UNITED STATES PATENT AND TRADEMARK OFFICE

APPLICATION NO.	FILING DATE	FIRST NAMED INVENTOR	ATTORNEY DOCKET NO.	CONFIRMATION NO.
10/823,160	04/13/2004	Kiyokazu Ohtaki	27,702 USA	4547
23307	7590	10/17/2006	EXAMINER	
SYNNESTVEDT & LECHNER, LLP			YANG, CLARA I	
2600 ARAMARK TOWER			ART UNIT	
1101 MARKET STREET			PAPER NUMBER	
PHILADELPHIA, PA 191072950			2612

Office Action Summary

DETAILED ACTION

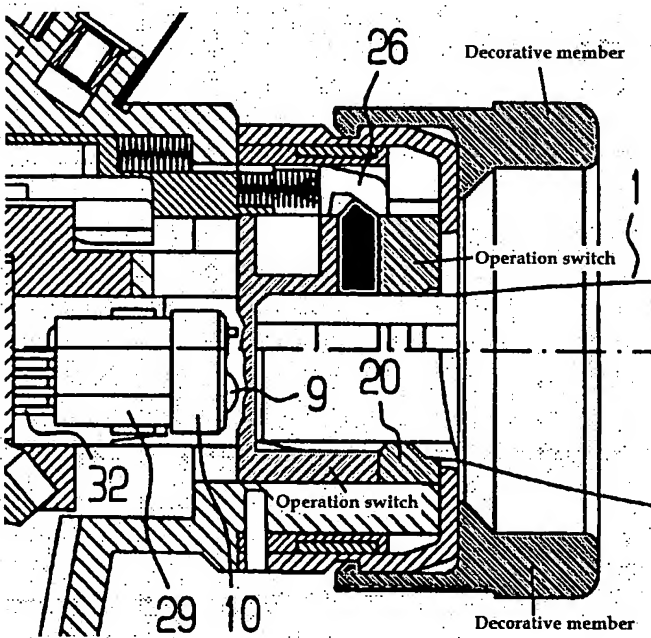
lines 56-67; Col. 4, lines 1-6 and 14-26; and Col. 6, lines 57-59). Schweiger's lock 7, as shown in Figs. 1-3 and in more detail in the figure on the left, includes (a) an operation switch, which includes receptacle 8 and is operated by an operator for starting the ignition (see Col. 3, lines 46-55; Col. 4, lines 4-67; and Col. 5, lines 1-7), (b) a decorative

member surrounding the operation switch, and (c) communication means 29 spaced from the decorative member and formed by lock-side receiver 9 and lock-side coil 10, which is wound around a ferromagnetic core, wherein communication means 29 transmits a transponder-driving radio wave that causes key 1's transponder to transmit its ID code, and the ferromagnetic core amplifies transponder-driving radio wave by increasing the magnetic field density (see Col. 3, lines 49-67; Col. 4, lines 1-6 and 14-26; Col. Col. 5, lines 35-43 and 55-59; and

Col. 6, lines 43-48 and 57-60). Schweiger omits specifying that the ferromagnetic core be made of an amorphous magnetic body or ferrite. Because the applicant does not traverse the examiner's assertion of official notice in the office action mailed on 3 May 2006 that ferromagnetic cores made of an amorphous magnetic body or ferrite are well known (see pages 7-8), the common knowledge or well-known in the art statement is taken to be admitted prior art. Hence it would have been obvious to one of ordinary skill in the art at the time the invention was made to modify Schweiger's ferromagnetic core such that it is made of an amorphous magnetic body, because an amorphous magnetic body has a lower melting point than pure iron and can be easily formed into a ring by injection molding or compression forming.

Therefore, it would have been obvious to one having ordinary skill in the art at the time the invention was made to modify the McConnell and Satoh's interrogator-coil circuit 70 as taught by Schweiger because disposing a ferromagnetic core inside antenna coil 80 increase the magnetic field density, thereby substantially reducing the amount of current required to generate the magnetic field (see Schweiger, Col. 5, lines 55-59). When the ferromagnetic core is inside antenna coil 80, the ferromagnetic core is arranged between interrogator-coil circuit 70 and bezel 20, as called for in claim 8, and isolated from interrogator-coil circuit 70 via housing 30's surface 44, which is made of plastic (see McConnell, Col. 3, lines 52-64); thus negative effects between interrogator-coil circuit 70, coil 80, and the ferromagnetic core, are reduced.
